APPLICATION NO.	FILING DATE	FIRST NAMED INVENTOR	ATTORNEY DOCKET NO.	CONFIRMATION NO.
10/618,521	07/11/2003	Thomas F. Calton	40682/298	5072
33642 7590 03/19/2009 STOEL RIVES LLP - SLC 201 SOUTH MAIN STREET, SUITE 1100			EXAMINER	
			SWIGER III, JAMES L	
ONE UTAH CENTER SALT LAKE CITY, UT 84111			ART UNIT	PAPER NUMBER
			3775	•
			MAIL DATE	DELIVERY MODE
			03/19/2009	PAPER

DETAILED ACTION

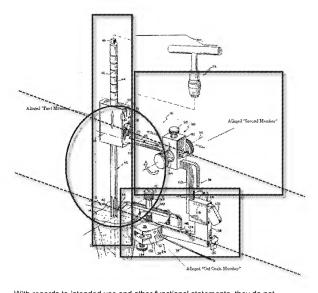
Claims 1-3, 4-6, 11, 25-26, 29, 32, 34, 35-37 are rejected under 35 U.S.C. 102(b) as being anticipated by Bowman et al. (US Patent 4,952,213). Bowman et al. ("Bowman") disclose an orthopedic cutting guide device (see entire Fig. 1, and see annotated drawing below) comprising a first member (entire section on left which has a pivot axis extending along the length defined by the body of the first member, extending from 48 to approx bottom at 42), a second member (L-shaped section extending to the right and down), a cut guide (24) releasably secured directly to the second member, and wherein the first member is positioned between a cut quide and the second member (to further clarify, two dotted lines have been drawn to denote exemplary bounds of a cut quide portion and a second member; the oval area represents what portion of the first member is positioned between the cut guide member and the second member), and further wherein the cut guide and second member are able to move together and pivot about the axis of the first member (see arrows 70, this can be a pivot of a first member which the 2nd member and cut guides can move together around). As the cut guide is adjustable, the second member may be selectively released from the first member. The cut quide member is also capable of independent movement from the second member. as they are adjustable with respect to one another and the first member. It is also noted

that the device is configured to be selectively adjusted in both a rotational and translational manner while at least a portion of the device is anchored. Note the arrows in the device denoting various types of movement. See drawing below.

Bowman further discloses an orthopedic cutting guide device that has at least one securing member (34) and a boom (142) that fits into an opening of the cutting guide (Fig. 1, inserted into top opening). The cutting guide also has various surfaces to assist in guiding a tool, the first member has various surfaces such as a first and second side, also has a tapering(ed) portion (42) which extends from a point on the first member. The cutting guide portions also have various holes.
